Rezoning Transportation Analysis

Petition Number: #2021-120

General Location Identifier: 09503403

Date	Description
09-28-2022	First Review (AO)
10-27-22	Second Review (TM)
11-28-22	Third Review (TM)

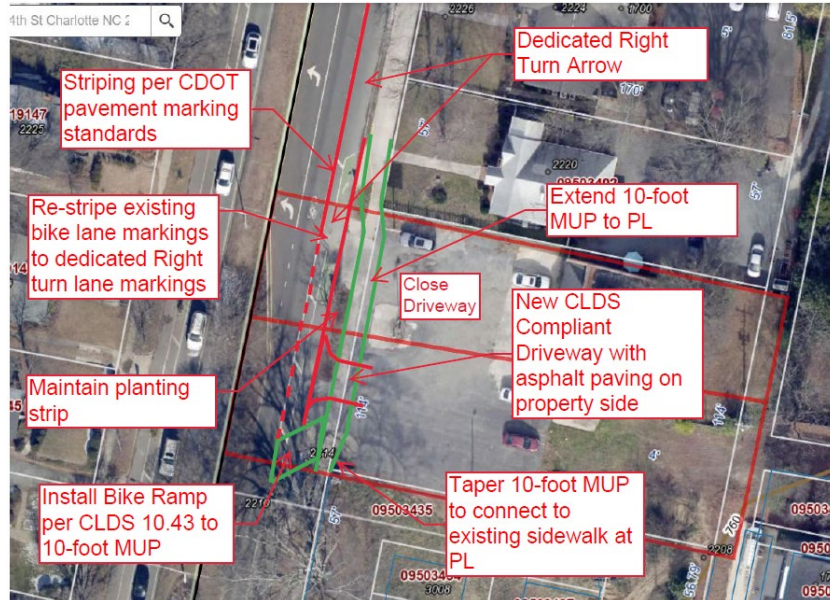
7. ~~Comment from 9-28-22:~~ Revise site plan and conditional note(s) to commit to remarking pavement markings and building a bike ramp near south property line to transition bicyclists from separated bike lanes to multi-use path.

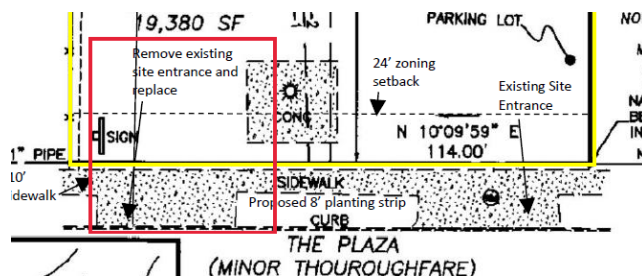
Outstanding Comment 10-26-22: After further coordination the above design has been updated as follows to. Revise site plan and conditional note(s) to commit to remarking current bike lane pavement markings to a dedicated right turn lane, a bike ramp near south property line per CLDSM 10.43 to transition bicyclists from separated bike lanes to multi-use path and extending the 10-foot multi-use path to the southern property.
